W3F1-2012-0102

Subject: Waterford 3 Supplemental Response to an NRC Request for Additional Information (RAI) associated with W3-ISI-020, Request for Alternative to ASME Code Case N-770-1 Baseline Examination [TAC No. ME9801]
Waterford Steam Electric Station, Unit 3
Docket No. 50-382
License No. NPF-38

Attachment 1 to W3F1-2012-0102
Supplemental Response to Request for Additional Information
Use of ASME Code Case N-770-1 Baseline Examination

Structural Integrity Associates, Inc.
TITLE: REACTOR COOLANT PUMP DISCHARGE DISSIMILAR METAL WELD

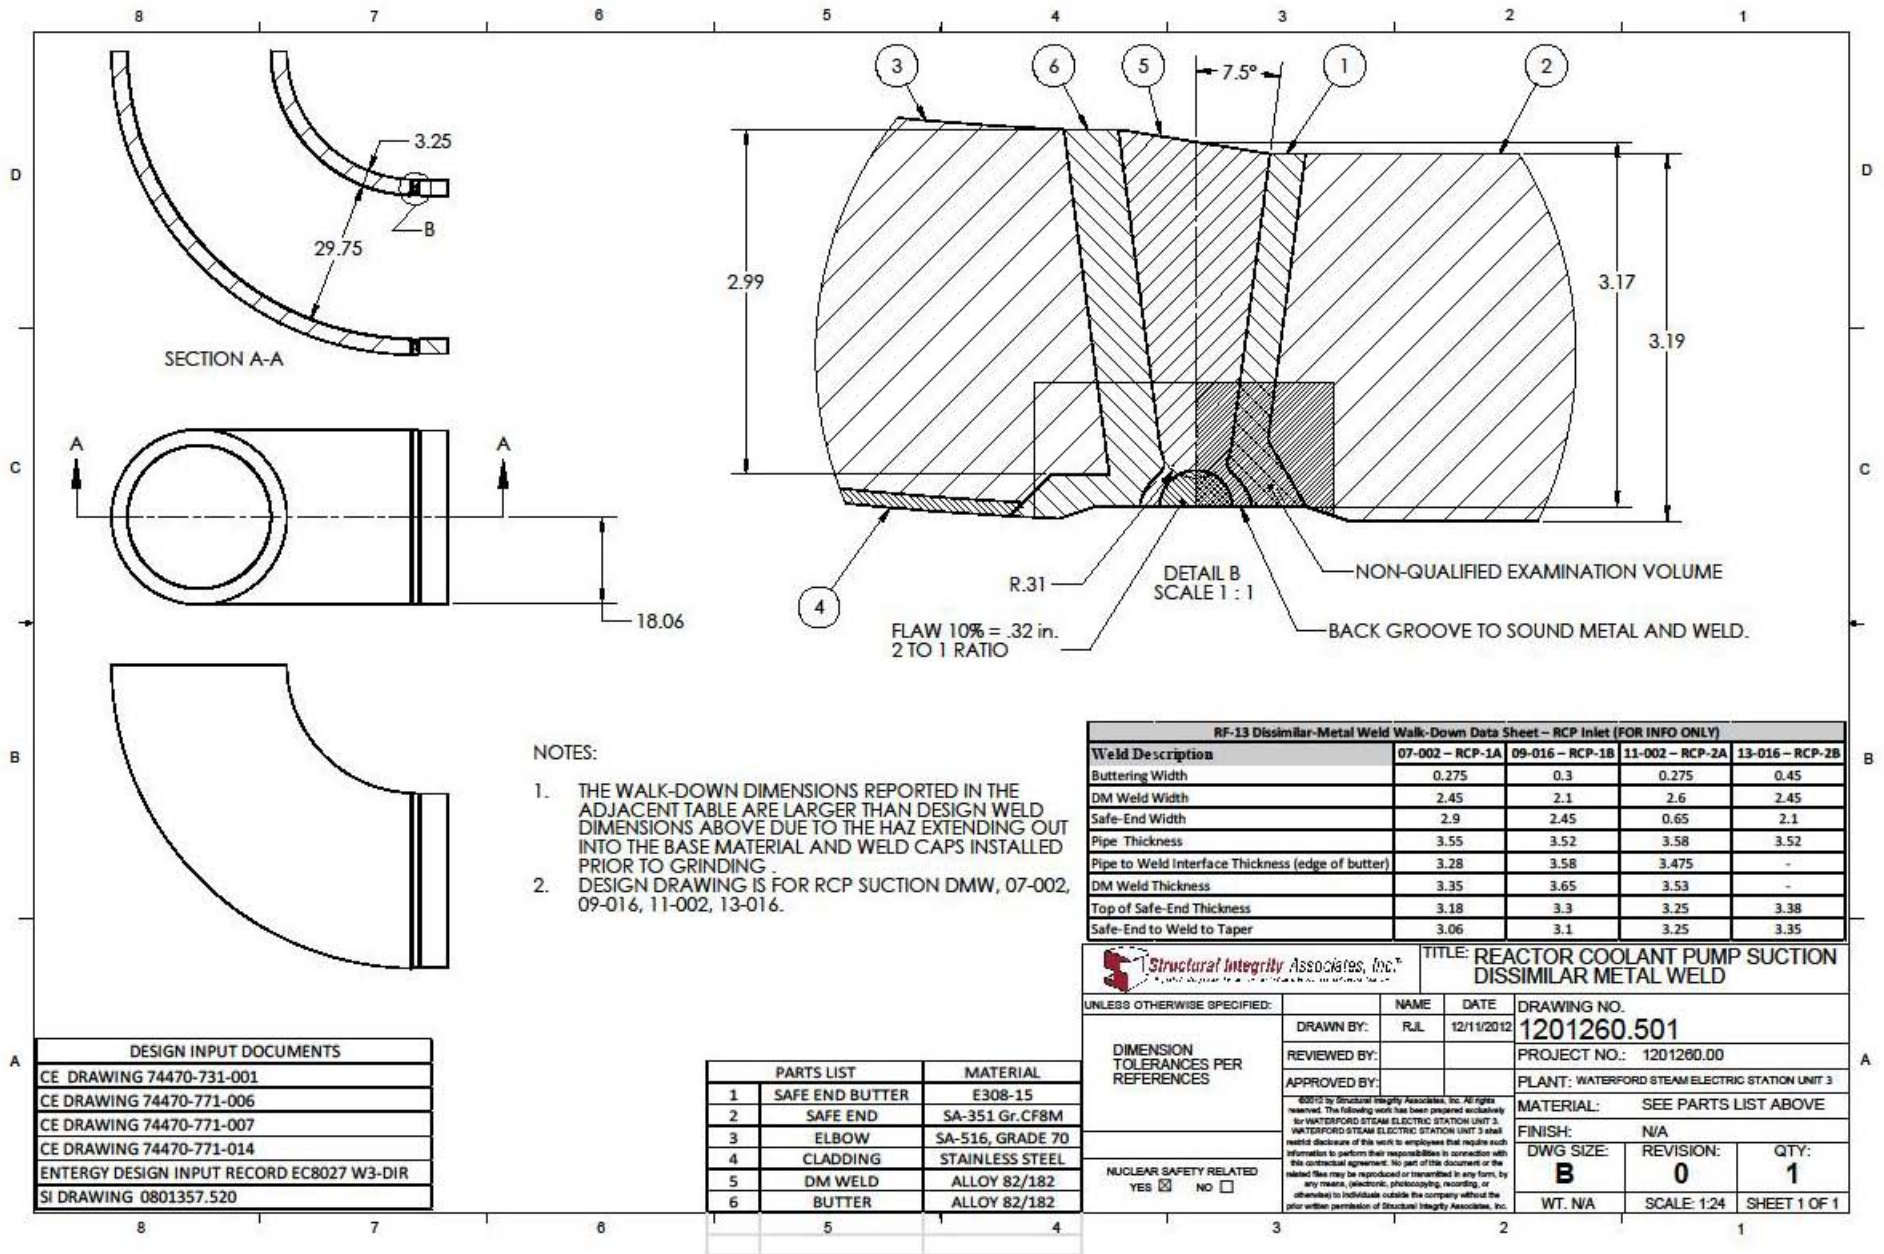
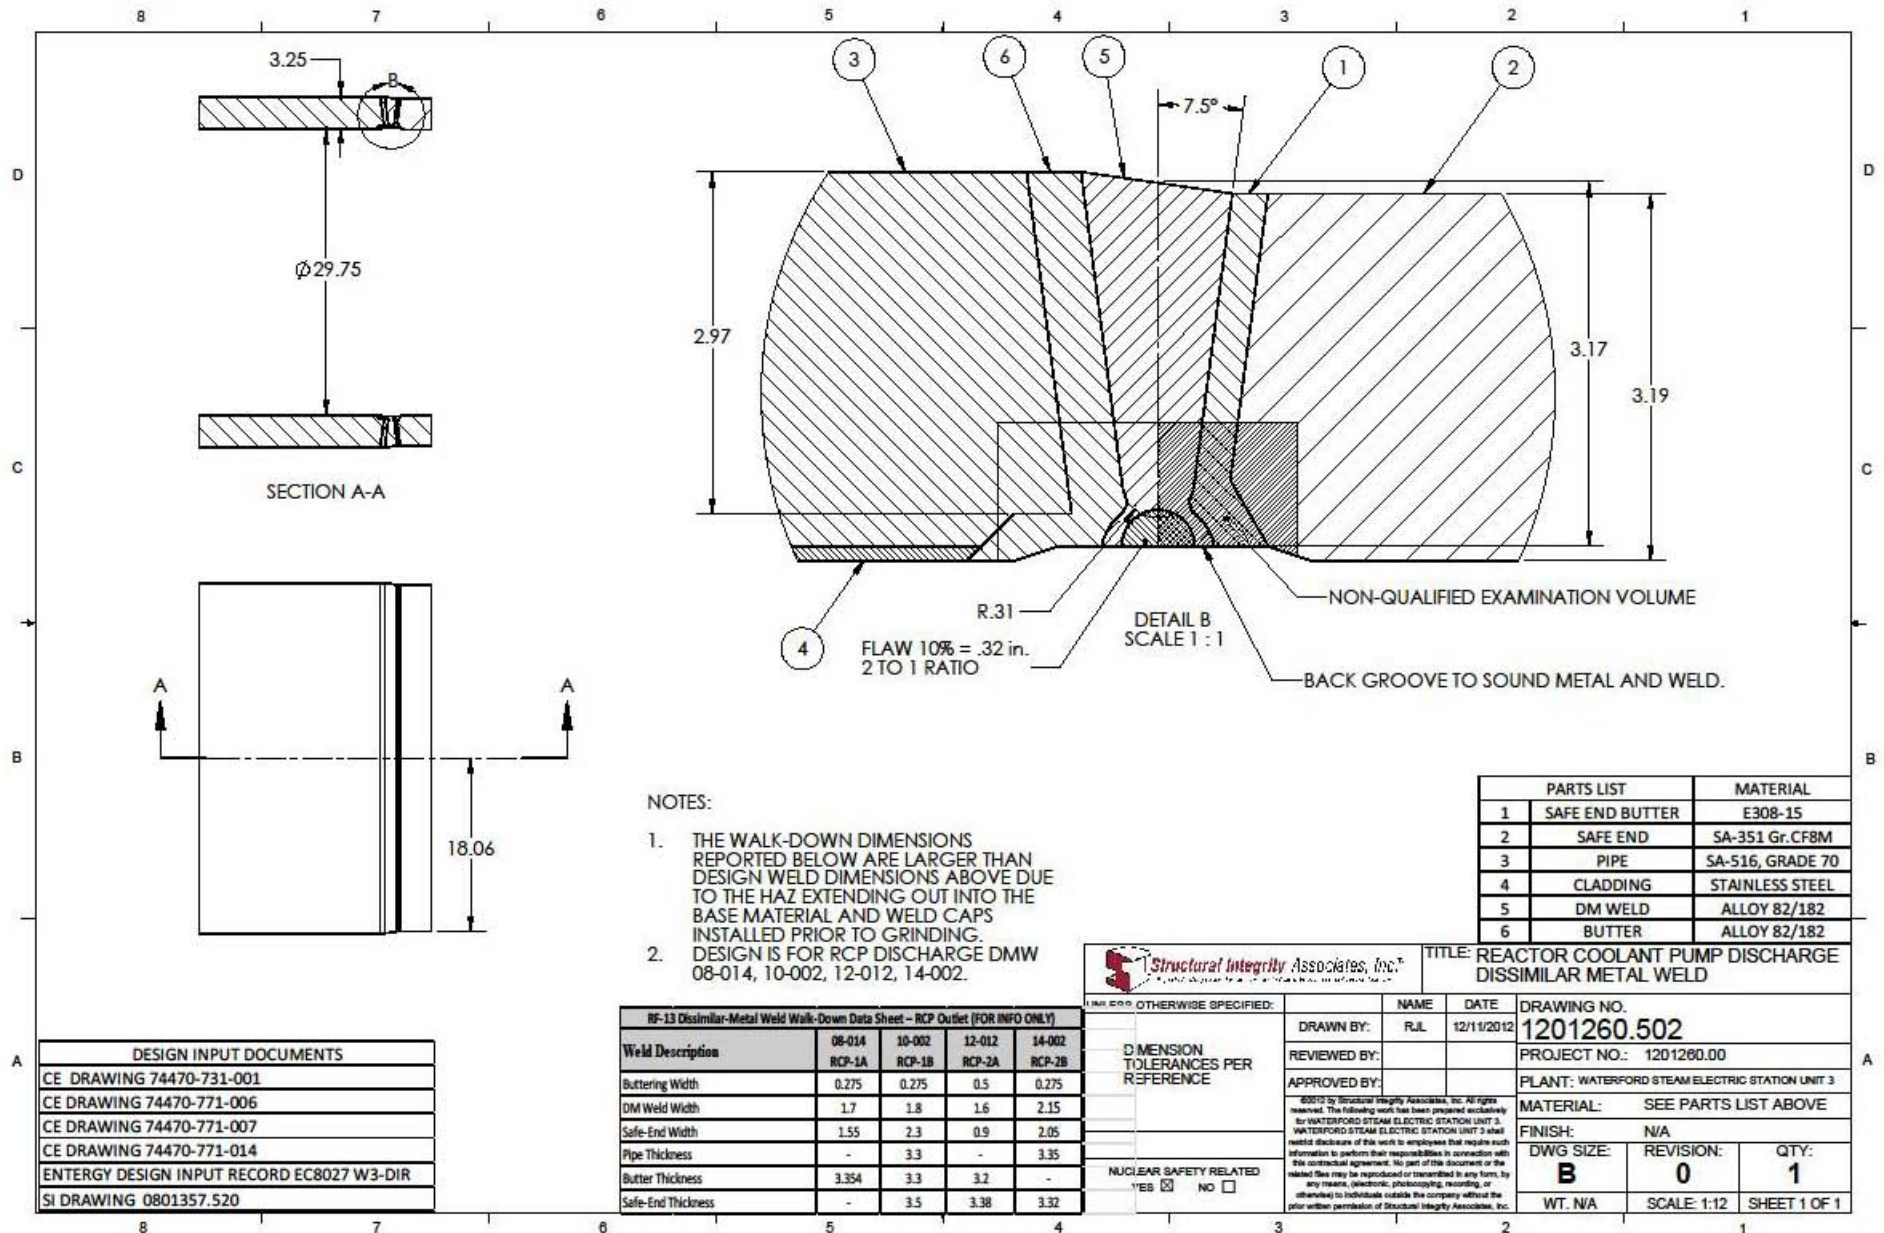
3. **Section 5 of the proposed alternative, “Proposed Alternative and Basis for Use,” states that the SI-UT-130 Rev. 3 UT procedure has been successfully qualified for single-sided axial scan examination, per the requirements of the ASME Code, Section XI, Appendix VIII**
 - c. **Provide data for the circumferential scan coverage of the susceptible material for the inner 1/3 of wall thickness of each of the subject welds**
 - i. **For each weld where the circumferential scan coverage of the susceptible material is less than 100 percent, please provide an axial cross sectional map indicating the unexamined zone and the size of largest potential flaw in the susceptible material within the unexamined zone**

Weld Flaw Location – Both the Reactor Coolant Pump (RCP) suction and discharge dissimilar metals have similar weld preps at the CASS safe-end and ferritic piping. The ferritic piping is buttered with an Alloy 82/182 filler metal. The CASS safe-end is buttered with a 308 Stainless Steel (SS) filler metal.

Westinghouse generic industry PWSCC flaw analyses considered an axial flaw in the center of the dissimilar metal (DM) weld as illustrated in the RCP suction and discharge drawings in Attachment 3 for the following reasons: The root of these welds requires an inside diameter (ID) backgroove to sound base and weld metal with a subsequent Alloy 82/182 backfill weld out. This process increases the residual stresses at the ID root. In addition, the weldment is diluted with the 308 SS on the stainless steel side. Therefore, if a PWSCC flaw were to initiate, it has a highest probability to occur in the centerline of the ID root weld. With an assumed flaw having a 2 to 1 aspect ratio and a 10% wall initial flaw depth, the assumed flaw would essentially cover the width of the root of the DM weld. This assumed flaw originating at the center of the DM weld is larger than and bounds a flaw originating from the corner near the stainless steel to DM weld root. As the flaw propagates through the weld, the axial length will continue to be conservatively greater than the width of the weld. Whereas if a flaw were assumed to initiate near the stainless steel to Alloy 82/182 weld interface, a corner type flaw would only grow in the direction of the susceptible material, resulting in a smaller flaw than the assumed centerline flaw. Additionally, the neighboring stainless weld has a beneficial effect on the DM weld for PWSCC (compressive residual stress). The only other possible crack initiation site is near Alloy 82/182 to clad interface. The axial flaw will arrest as it radially intersects the carbon steel pipe. Crack propagation beyond the carbon steel ID from the clad would have been readily detected from the past examination. Therefore, the most conservative crack location is at the centerline of the weld root.

qualified examination volume, and thus increase the "detection margin" from the Supplement 8 defined areas proportionally. Therefore, a 10% 2 to 1 flaw is concluded to have sufficient reflective area to support detection within the qualified volume. Entergy has established the weld root cross-sections for the subject welds by use of design drawings and other design documents to properly characterize the expected flaw heights (Attachment 3).
